**Subject: Addendum #1
Two Boilers for Kings Fork Middle School**

Please note the following questions received regarding the above IFB.

ENLARGED BOILER ROOM PLAN
M4.5 - 1 - OF

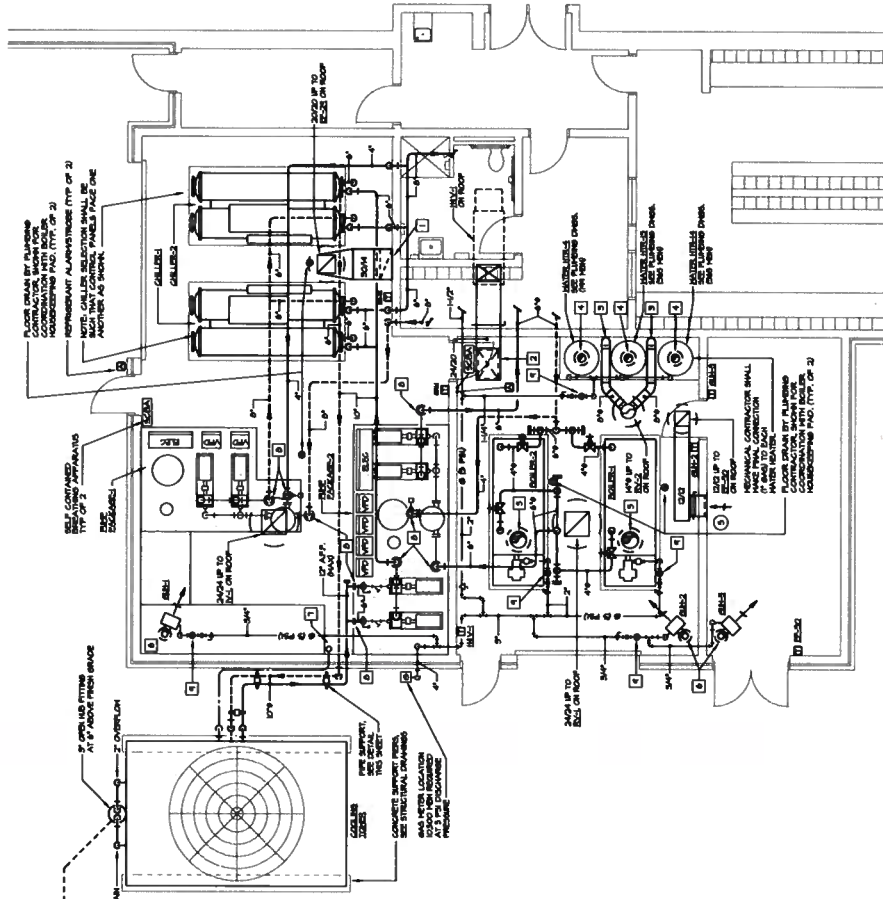
Question: Due to the amount of existing piping and electrical conduits in the path from the new boilers to above the existing roll up doors. Would it be permissible to run the combustion air up and through the roof?

Answer: SPS prefers combustion air piping be run through the wall as indicated in the bid documents
